# Final Environmental Impact Report for City of Santa Barbara's and Ionics, Incorporated's Temporary Emergency Desalination Project

**DATE:** March 20, 1991  
**TO:** All Interested Parties  
**FROM:** Mitch H. Oshinsky, Principal Planner *MHO*  
**SUBJECT:** FINAL ENVIRONMENTAL IMPACT REPORT FOR TEMPORARY  
EMERGENCY DESALINATION PROJECT (SB-106-90)

**DATE:** March 20, 1991  
**TO:** All Interested Parties  
**FROM:** Mitch H. Oshinsky, Principal Planner *MHO*  
**SUBJECT:** Final Errata for Temporary Emergency FEIR

Figure 2-2

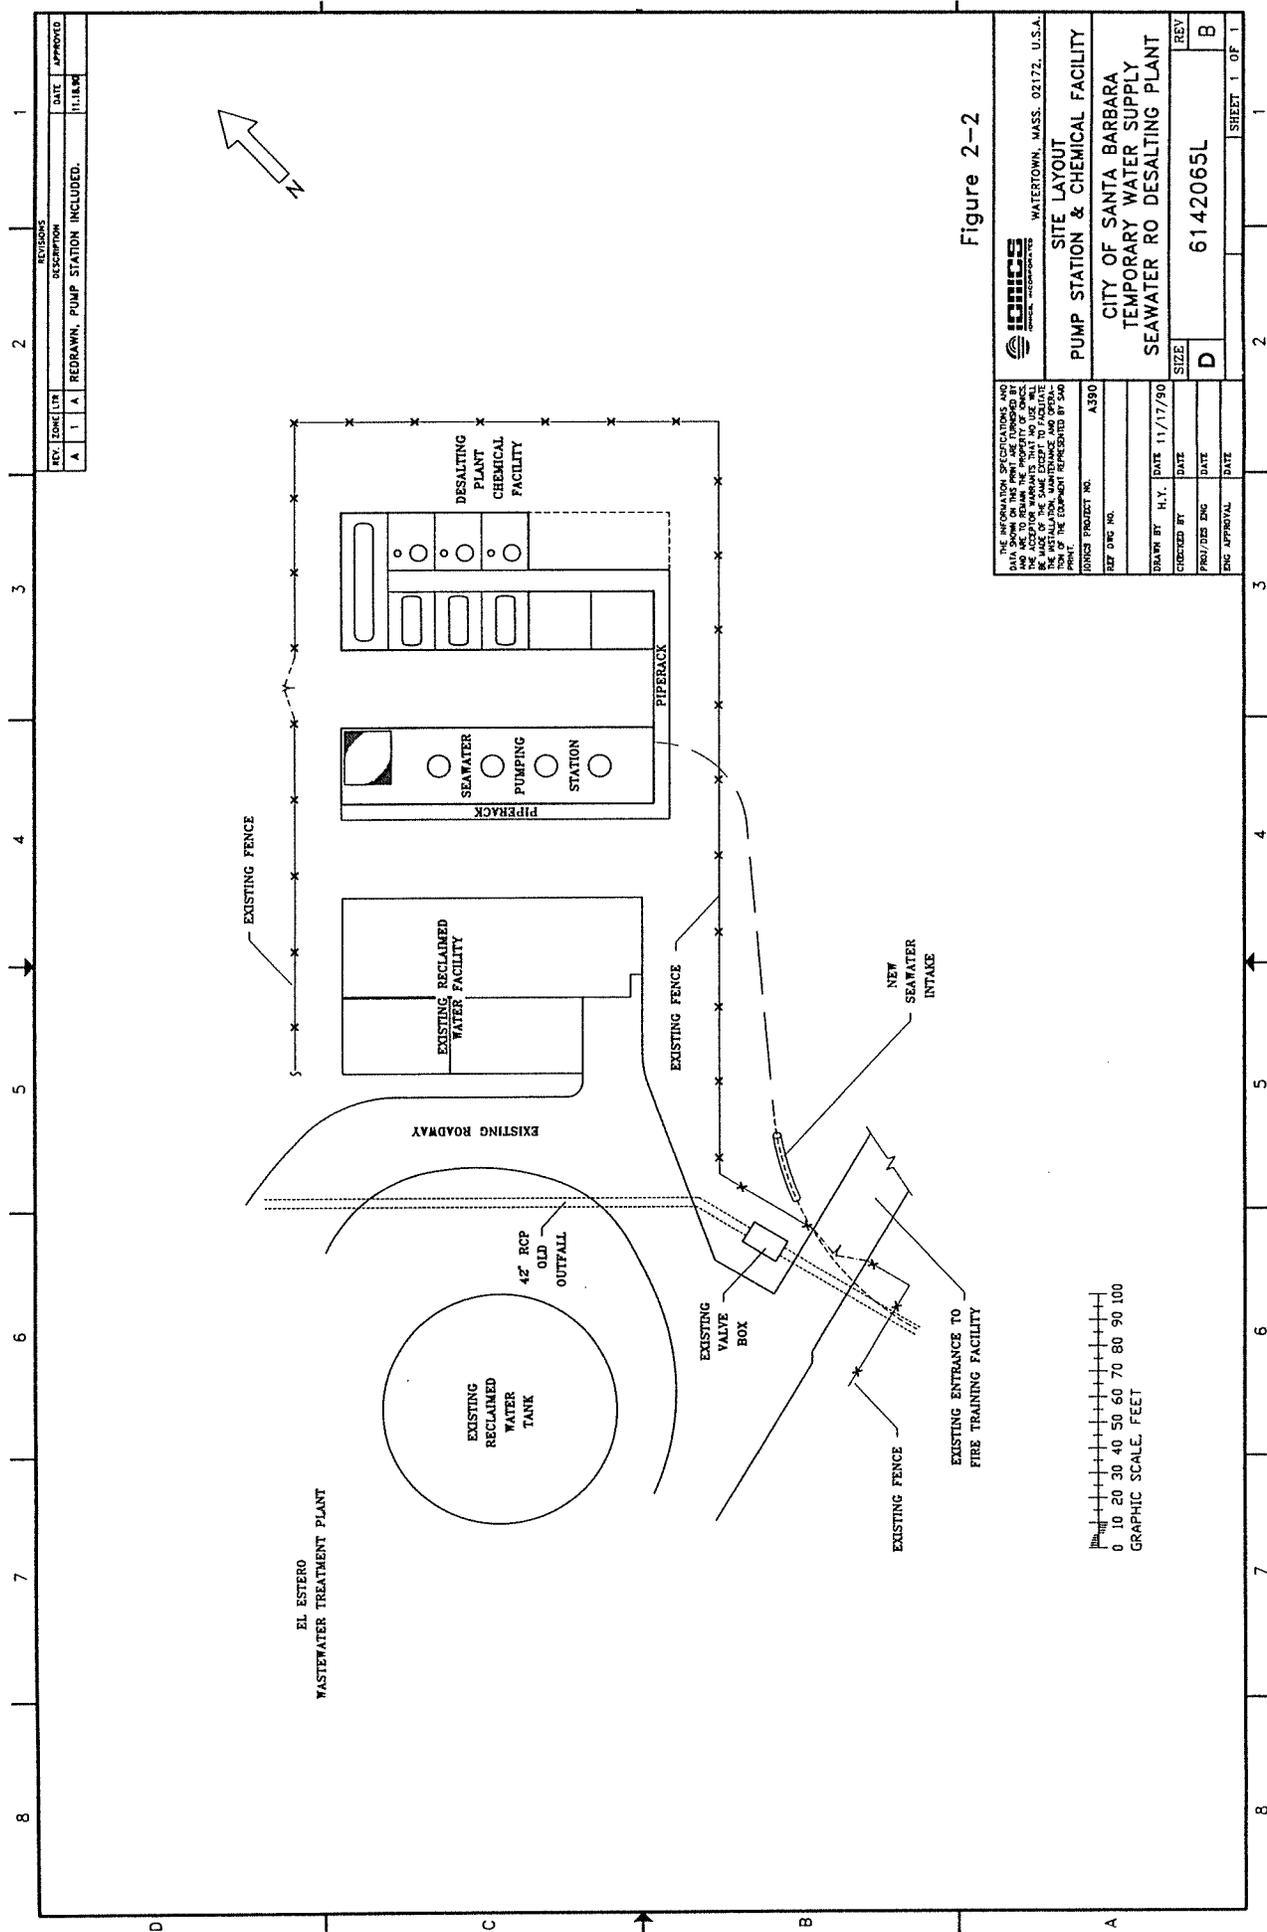
11. P. 2-11, Figure 2-2, beginning with this figure, much of the type on the figures is small and hard to read, it should be enlarged with an easier to read type.

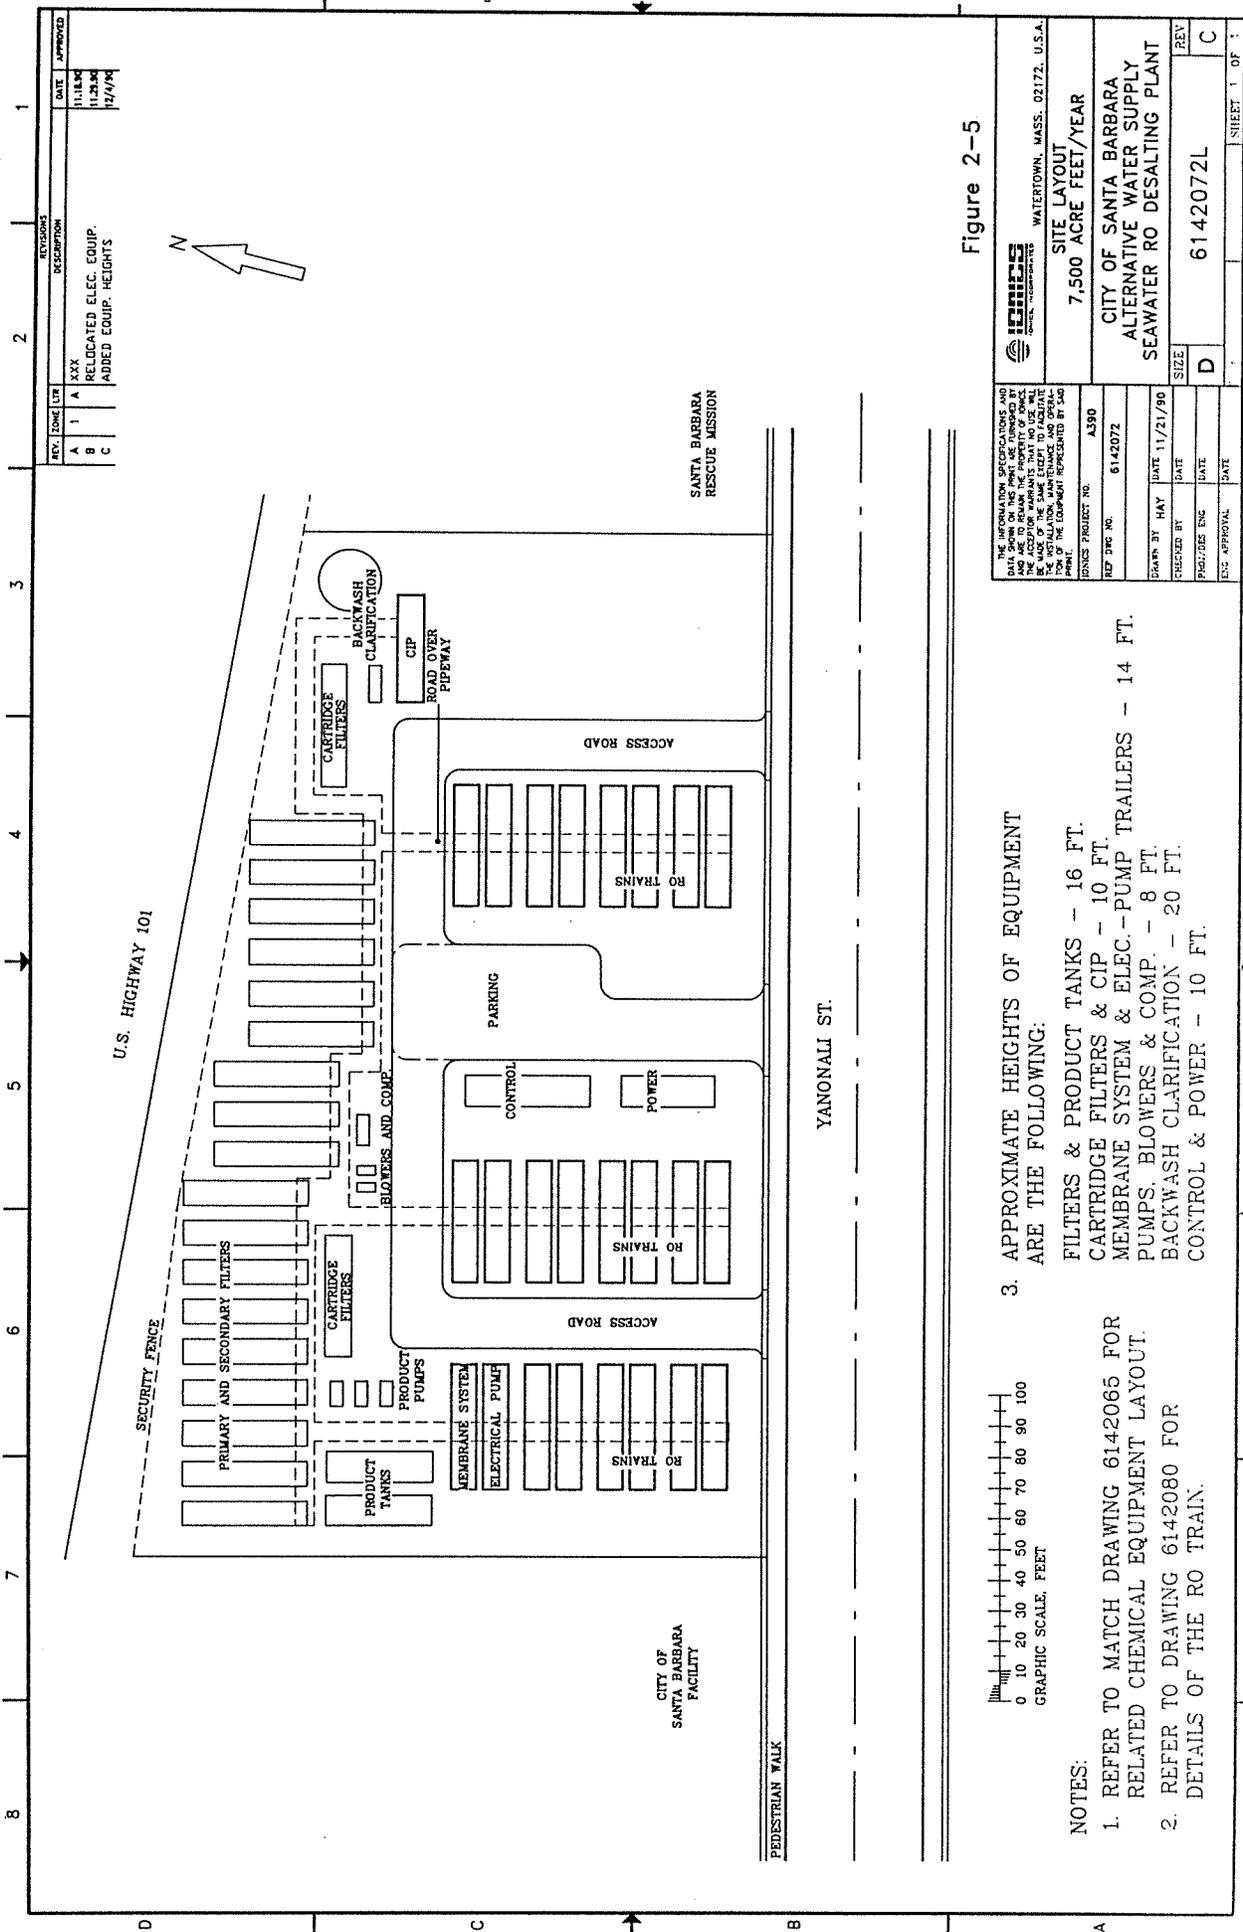
Response 9-22: The commentor incorrectly claims that there has not been data provided regarding the clarifier or dewatering filter press in the EIR, and that there is probably not enough room at the site for these facilities without reducing the capacity of the desalination facility. In actuality, both of these facilities are addressed in the EIR. The clarifier is shown on the artist's rendering in the lower left hand corner (tank structure), and on Figures 2-3 and 2-5 on the northeast corner of the site. As listed on the figures, the backwash clarifier is 20 feet tall (i.e., tallest structure at site). The dewatering filter press is also shown on Figures 2-3 and 2-5 to the west of the backwash clarifier; due to space limitations on the

figures, the press was not labeled. Labels for the dewatering filter press have been added to Figures 2-3 and 2-5 in the Final EIR.
